BRANDY SUBDIVISION, RESUBDIVISION OF LOTS 2 & 3

APPLICATION NUMBER _____8_____ DATE _____October 20, 2005_____

REQUEST _____Subdivision_____

LOCATOR MAP

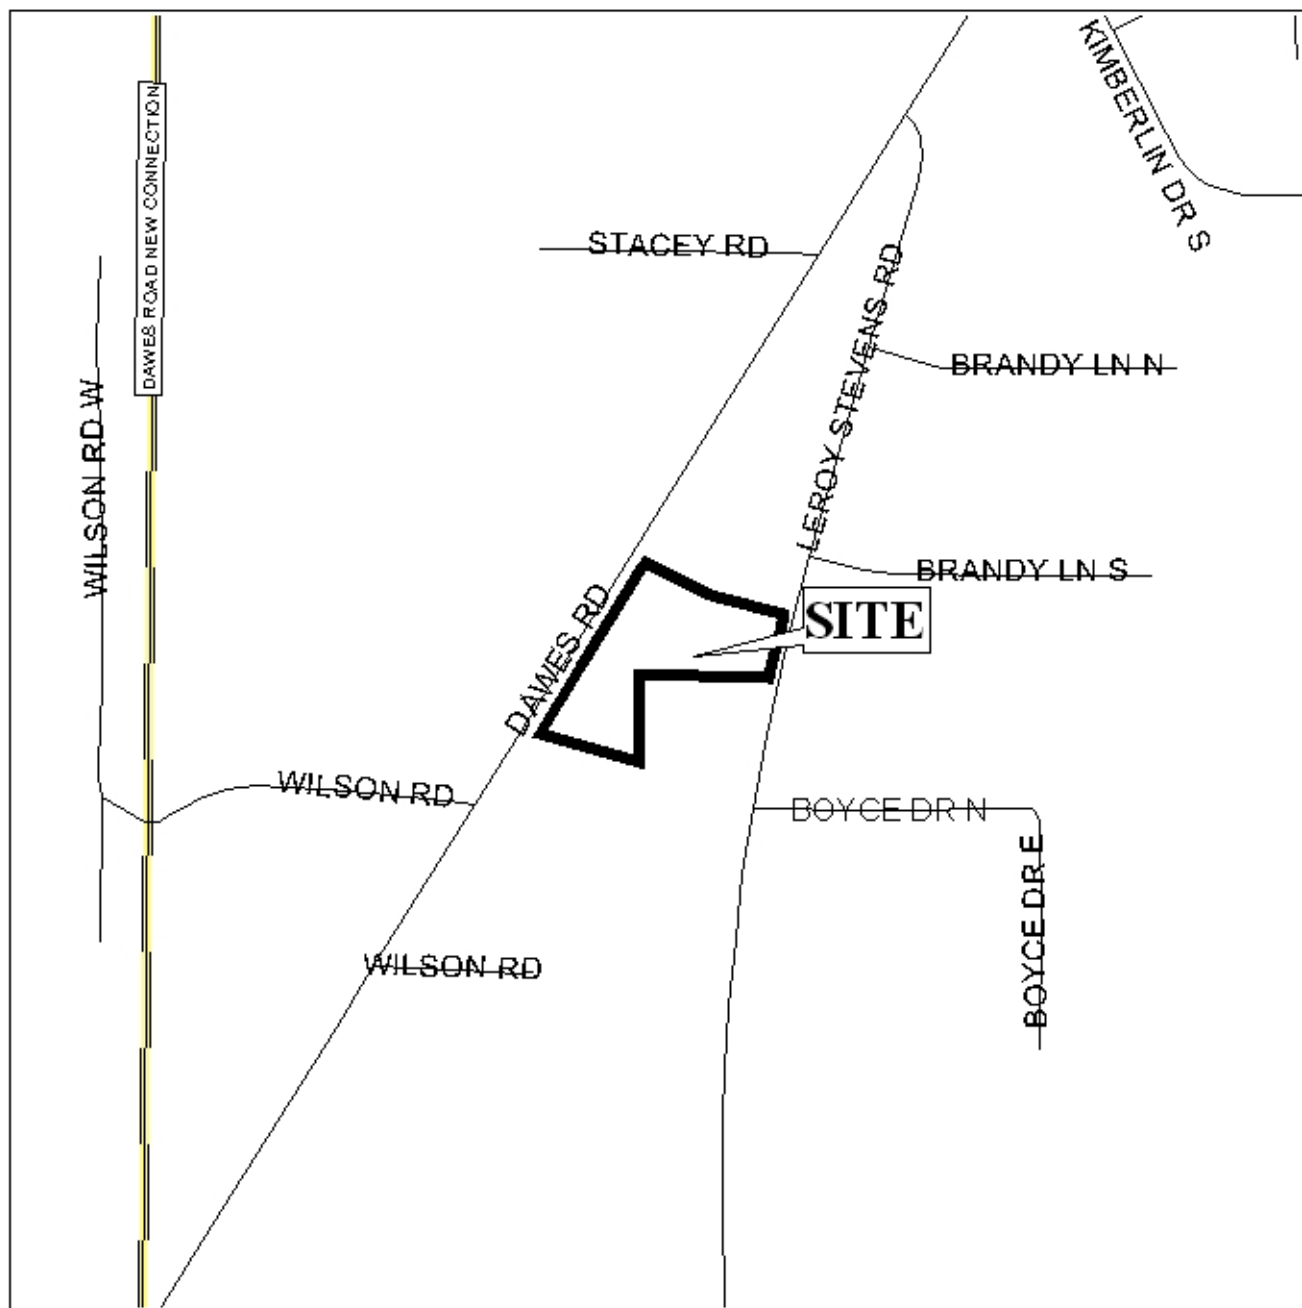
As indicated on the Vicinity Map, Lot C fronts both Dawes Road and Leroy Stevens Road. Therefore, as a means of access management, a note should be placed on the final plat stating that Lot C is limited to one curb cut for only one street (Leroy Stevens Road) to avoid potential cut through traffic.

The plat meets the minimum requirements of the Subdivision Regulations and is recommended for Tentative Approval subject to the following conditions: 1) the placement of a note on the final plat stating that Lot C is limited to one curb cut for only one street (Leroy Stevens Road); 2) the placement of a note on the final plat stating that any property that is developed commercially and adjoins residentially developed property shall provide a buffer, in compliance with Section V.A.7. of the Subdivision Regulations; and 3) the placement of the 25-foot minimum setback lines on the final plat.
